RE: Files Approved for Scanning

Plan approved to modify outlet structure from BMP Norge Center site - 7151 Richmond Road DEC 2/1/06

NORGE NEIGHBORHOOD

Darryl -
The attached plan change is in response to a request by James Neal from the Norge Office Park. The added inlet is to help relieve current flooding issues. Please call if you have any questions.

REVISED STORM SYSTEM

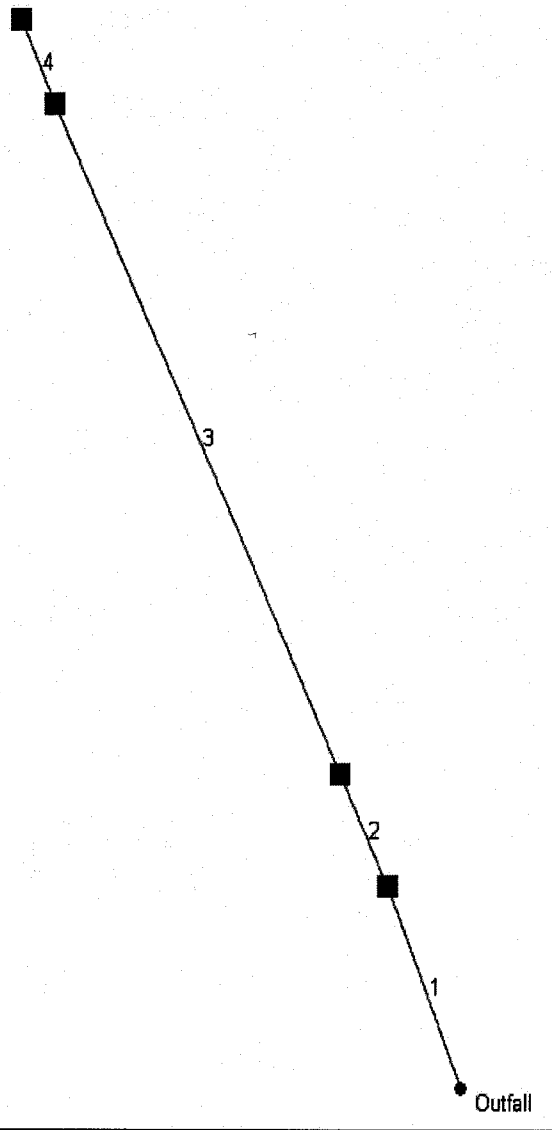
Hydraflow Plan View

Increased Volumn from Existing to Proposed

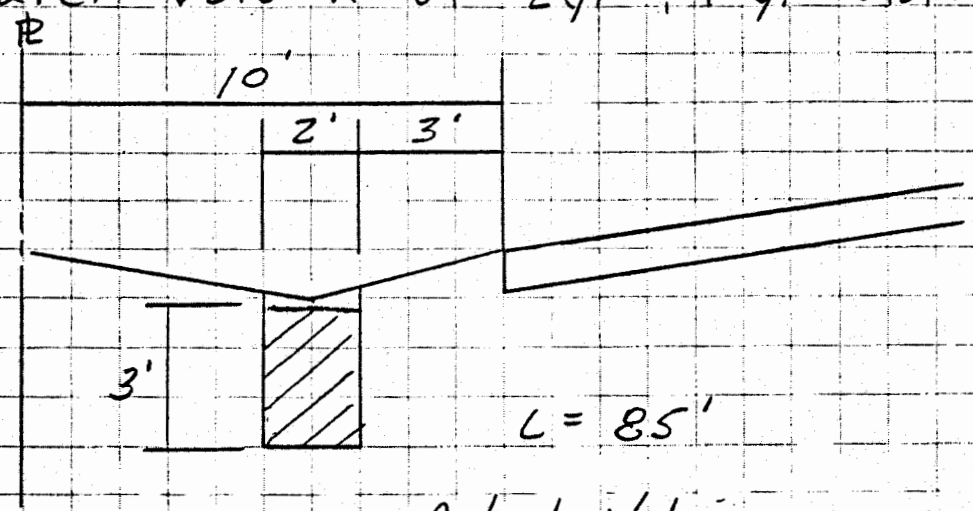
$Vol_2 = 540$ c.f. $- 384$ c.f. $=$ ~~156 c.f.~~
227 ft^3 / .4 = 567 ft^3

$Vol_{10} = 708$ c.f. $- 504$ c.f. $=$ ~~204 c.f.~~
307 ft^3 / .4 = 768 ft^3

1" Vol = 711.5 ft^3 ✓ 50 YR = 619 ft^3 ✓
